Access Compliance Report

Public Rights-of-Way

Intersection ID: 48495	Main Street: LOCH_LOMOND_DR	Cross Street: BEREWICK_COMMONS_PY	Location: S
ADA ID: 2AB533EFD640	Ramp Type: Perp	Initial Pass/Fail: Fail	Overall Compliance: No
Severity Score: 12.5			
Codes/Mitigation Info/Possible Solution		Field Measurements/Component Compliance

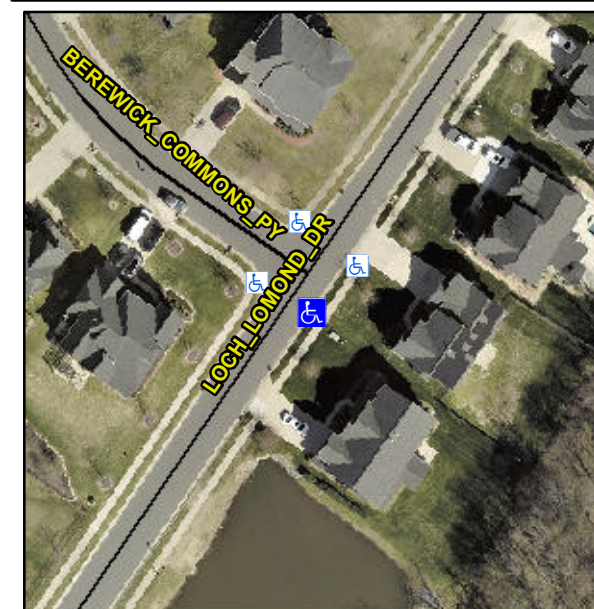
Not Found, R304.2.2

Compliance	Description	Data	Compliance	Description	Data
N/A	Ramp Length (in)	47.0	No	Ramp Slope (%)	8.9
Yes	Ramp Width (in)	48.0	Yes	Ramp XSlope (%)	0.7
N/A	Flare Type LT	N/A	N/A	Flare Type RT	N/A
N/A	Flare Slope LT (%)	N/A	N/A	Flare Slope RT (%)	N/A
N/A	Flare Traversable LT?	N/A	N/A	Flare Traversable RT?	N/A
N/A	Landing Length (in)	N/A	N/A	DWS Provided?	N/A
N/A	Landing Width (in)	N/A	N/A	DWS Contrast?	N/A
N/A	Landing Slope (%)	N/A	N/A	DWS Length (in)	N/A
N/A	Landing X Slope (%)	N/A	N/A	DWS Full Width?	N/A
N/A	Landing Curb? (Y/N)	N/A	N/A	DWS Offset (in)	N/A
N/A	Shared Landing?	N/A			
N/A	Gutter Ponding?	N/A	N/A	Gutter Slope (%)	N/A
N/A	Gutter Lip Ht (in)	N/A	N/A	Gutter X Slope (%)	N/A
N/A	Painted X Walk1?	No	N/A	Painted X Walk2?	N/A
	X Walk 1 Direction	To NW		X Walk 2 Direction	N/A
N/A	X Walk 1 Width (in)	N/A	N/A	X Walk 2 Width (in)	N/A
	X Walk 1 Slope (%)	2.7		X Walk 2 Slope (%)	N/A
	X Walk 1 X Slope (%)	0.8		X Walk 2 X Slope (%)	N/A

Remove & Replace Entire Ramp.
